# Access Compliance Report

## Public Rights-of-Way

### (Curb Ramps)

Intersection ID: 10015635	Main Street: HARRIS_CORNERS_PY	Cross Street: N/A	Location: W
ADA ID: BF8CCA9752DF	Ramp Type: BlendTrans2	Initial Pass/Fail: Fail	Overall Compliance: No
Severity Score: 8.75			
Codes/Mitigation Info/Possible Solution		Field Measurements/Component Compliance

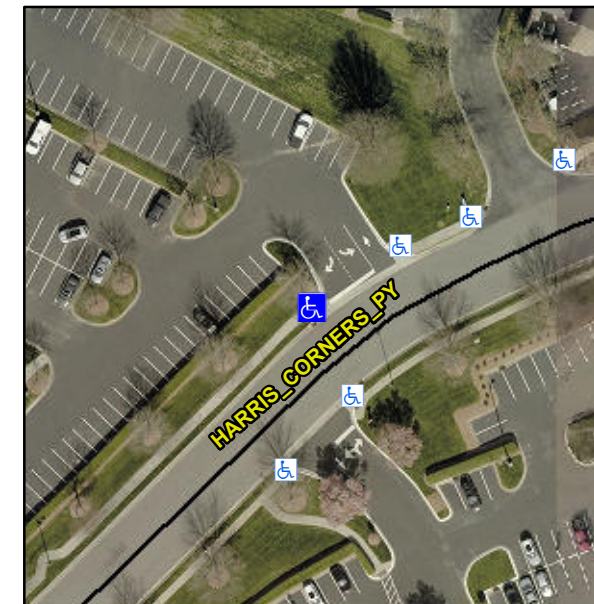
**Not Found, R304.5.1**

Compliance	Description	Data	Compliance	Description	Data
N/A	Ramp Length (in)	58.0	Yes	BlendTrans Slope (%)	3.4
No	Ramp Width (in)	42.0	Yes	BlendTrans XSlope (%)	1.2
N/A	Flare Type LT	N/A	N/A	Flare Type RT	N/A
N/A	Flare Slope LT (%)	N/A	N/A	Flare Slope RT (%)	N/A
N/A	Flare Traversable LT?	N/A	N/A	Flare Traversable RT?	N/A
N/A	Landing Length (in)	N/A	N/A	DWS Provided?	N/A
N/A	Landing Width (in)	N/A	N/A	DWS Contrast?	N/A
N/A	Landing Slope (%)	N/A	N/A	DWS Length (in)	N/A
N/A	Landing X Slope (%)	N/A	N/A	DWS Full Width?	N/A
N/A	Landing Curb? (Y/N)	N/A	N/A	DWS Offset (in)	N/A
N/A	Shared Landing?	N/A			
N/A	Gutter Ponding?	N/A	N/A	Gutter Slope (%)	N/A
N/A	Gutter Lip Ht (in)	N/A	N/A	Gutter X Slope (%)	N/A
N/A	Painted X Walk1?	No	N/A	Painted X Walk2?	No
	X Walk 1 Direction	To S		X Walk 2 Direction	To NE
	X Walk 1 Width (in)	N/A		X Walk 2 Width (in)	N/A
	X Walk 1 Slope (%)	0.9		X Walk 2 Slope (%)	0.5
	X Walk 1 X Slope (%)	0.2		X Walk 2 X Slope (%)	0.4

N/A	Ramp inside XWalk1?	N/A	N/A	Ramp inside XWalk2?	N/A
	Road Slope (%)	0.3		Clear Space?	N/A
	Road X Slope (%)	0.4	N/A	Clear Space to XWalk (in)	N/A
N/A	Any Obstructions?	N/A	N/A	Storm Grate/Utility Hazard?	N/A
	Obstruction Type			Storm Grate/Utility Type	
		N/A			N/A
			Yes	Surface Condition? (G/P)	Good
			No	Curb Slope (%)	7.1

**Remove & Replace Curb Ramp With Two New Directional Ramps or Equivalent.**
